HISTORIC AND DESIGN REVIEW COMMISSION

July 19, 2023

HDRC CASE NO:	2023-249
ADDRESS:	1020 BURNET ST
LEGAL DESCRIPTION:	NCB 1660 BLK H LOT N 50 FT OF 6
ZONING:	R-6, H
CITY COUNCIL DIST.:	2
DISTRICT:	Dignowity Hill Historic District
APPLICANT:	Yolanda Guajardo/BRIDGE GROUP LLC
OWNER:	Yolanda Guajardo/BRIDGE GROUP LLC
TYPE OF WORK:	New construction of a one-story accessory structure
APPLICATION RECEIVED:	June 06, 2023
60-DAY REVIEW:	August 5, 2023
CASE MANAGER:	Jessica Anderson
REQUEST:

The applicant requests a Certificate of Appropriateness for approval to construct a 392-square-foot detached accessory structure.

A6

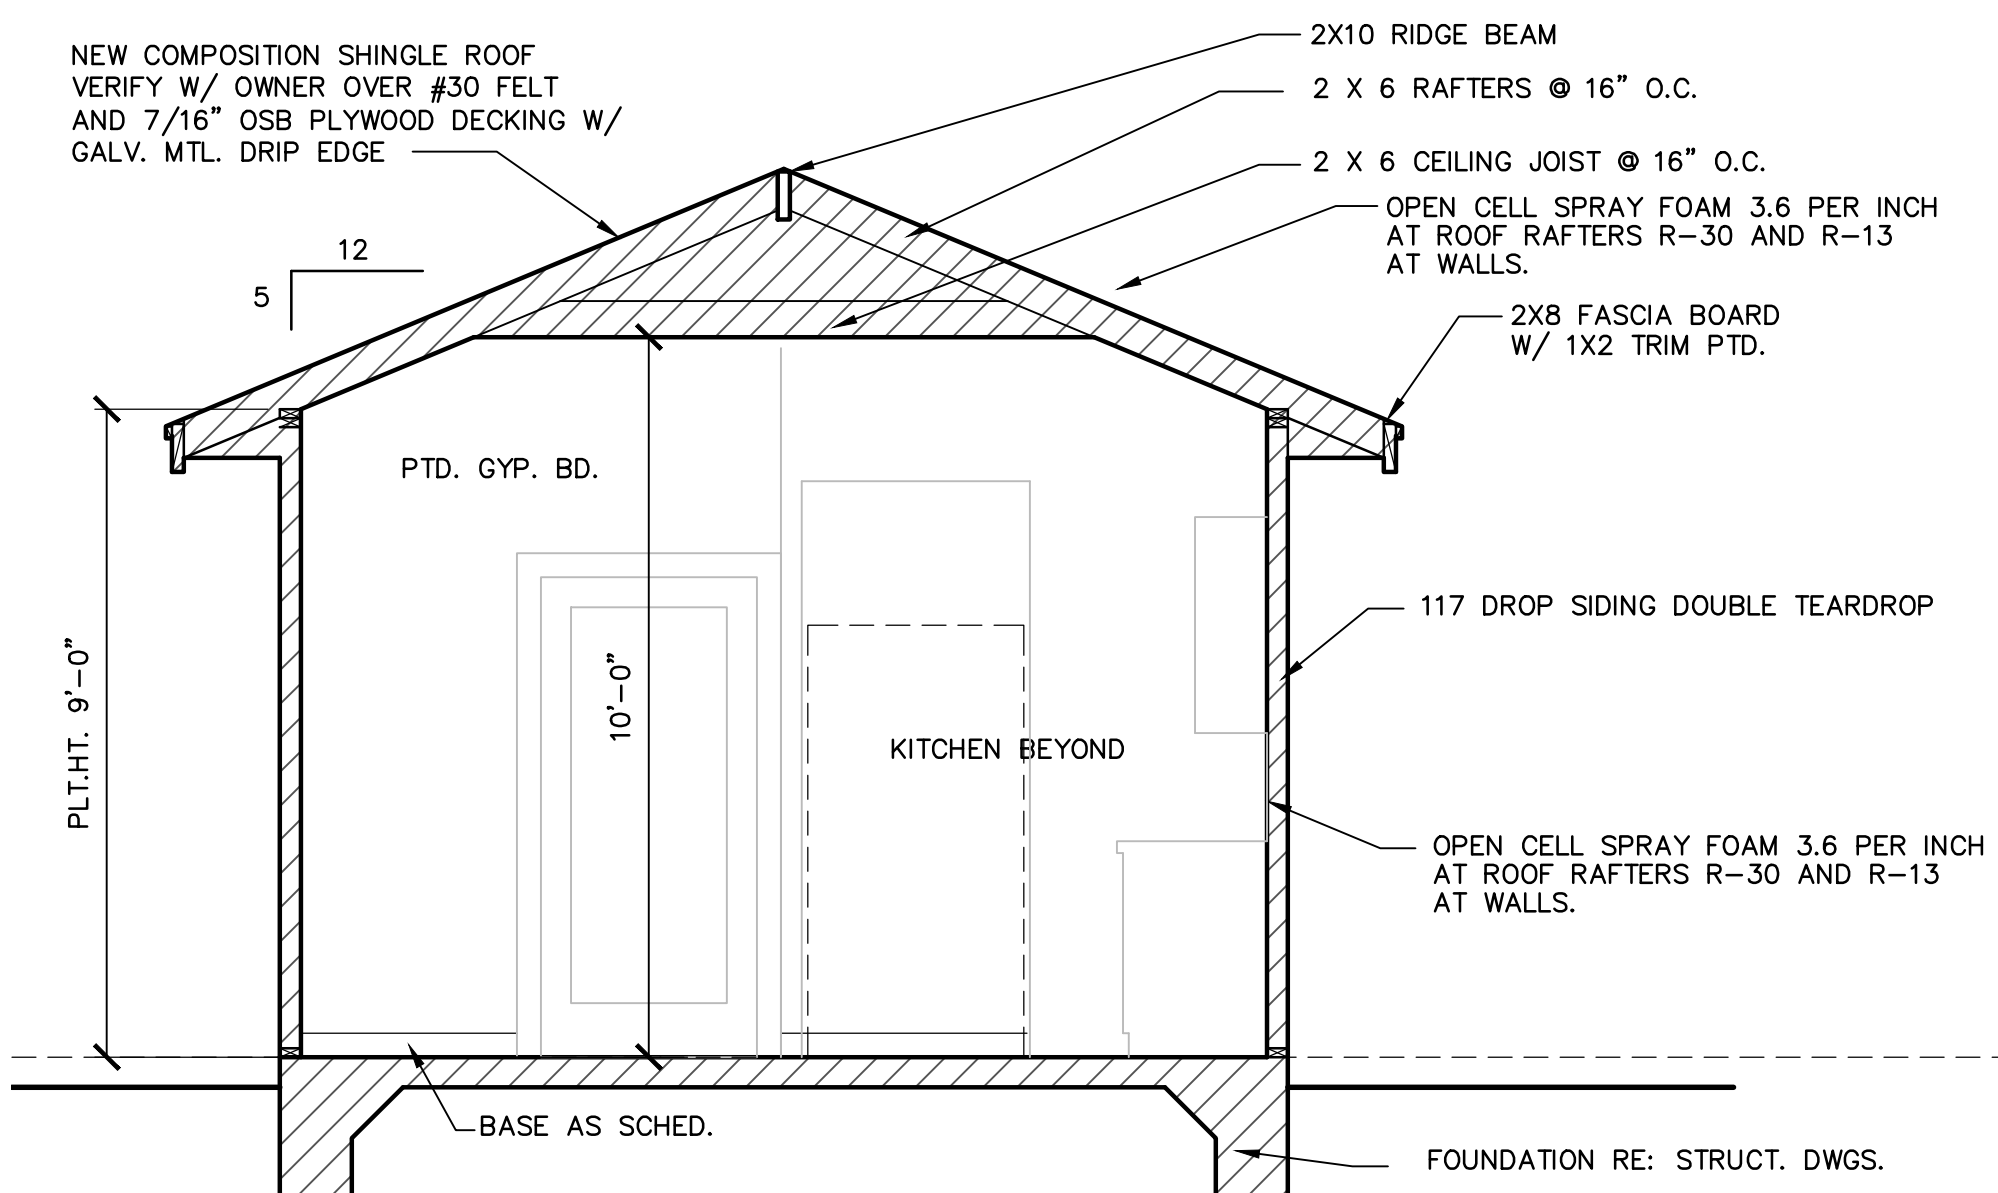
- e. **WINDOWS (MATERIAL):** The applicant proposes two one-over-one vinyl windows on the north elevation, flanking the front door. Windows on the primary historic structure are rectangular one-over-one wood windows that appear in ganged pairs, ganged threes, or individually. Per Standard Specifications for Windows in Additions and New Construction, new windows on additions should relate to the windows of the primary historic structure in terms of materiality and overall appearance. While no material is expressly prohibited by the Historic Design Guidelines, a high-quality wood or aluminum-clad wood window product often meets the Guidelines. Staff finds the proposed window material is not consistent with these specifications.

- f. **WINDOWS (RELATIONSHIP OF SOLIDS TO VOIDS):** The applicant proposes two one-over-one windows on the north elevations, but does not include any windows on the other three elevations of the proposed accessory structure. Historic Design Guidelines for New Construction 2.C.1 says to incorporate window and door openings with a similar proportion of wall to window space as typical with nearby historic facades. Staff finds the proposed accessory structure does not conform to guidelines.

- i. That the applicant proposes a window product that conforms to Standard Specifications for Windows in Additions and New Construction, specifically a wood or aluminum-clad wood window product, as stated in finding e.
- ii. That the applicant introduces windows on the south, east, and west elevations, as stated in finding f.
